GROWTH MANAGEMENT DEPARTMENT STAFF REPORT
VILANO BEACH TOWN CENTER OVERLAY DISTRICT
December 14, 2022 Public Meeting
VBTCDR 2022-10 180 Vilano Road

Summary of Request: Applicant is requesting design approval to enclose and cover an existing concrete pad to enable additional outdoor seating.

OUTSIDE ADDITIONS FOR:
180 VILANO GRILL
180 VILANO ROAD FLORIDA
ST. JOHNS COUNTY

EAST ELEVATION (WEST ELEVATION SIMILAR O.H.)
SCALE: 1/4" = 1'-0"

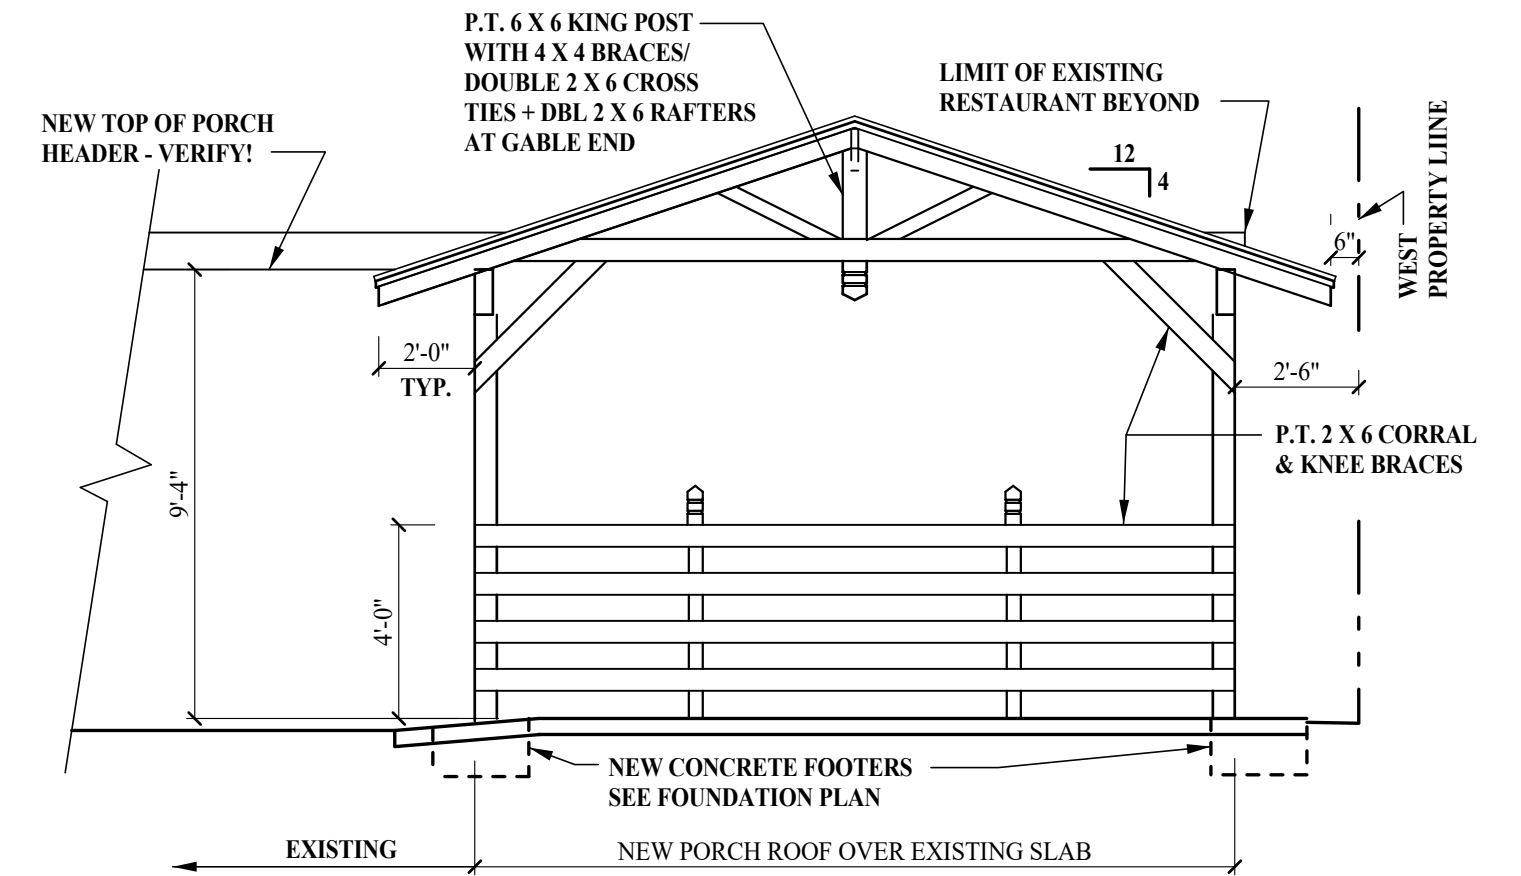
3. All buildings constructed within Town Center Mixed Use District shall have a minimum ground floor, floor to ceiling height of 12 feet. *Proposed pavilion does not appear to surpass existing building height.*

5. Exterior finish materials shall be appropriate for the style of the building, and shall be limited to light colored, stone, brick, stucco, pre-cast concrete, clear glass, clapboard siding, or wood shingles. Walls shall be of no more than two materials, and shall change material along a horizontal line, with the heavier material below the lighter material. *Pavilion is proposed to consist of natural wood, with a fence style enclosed area, and an aluminum roof.*

11. Pitched roofs are allowed and where used shall be of silver colored metal. Flat roofs shall be enclosed by parapets no less than forty two (42) inches high, or as required to enclose equipment. *Proposed sloped pavilion roof is to be aluminum/metal material.*
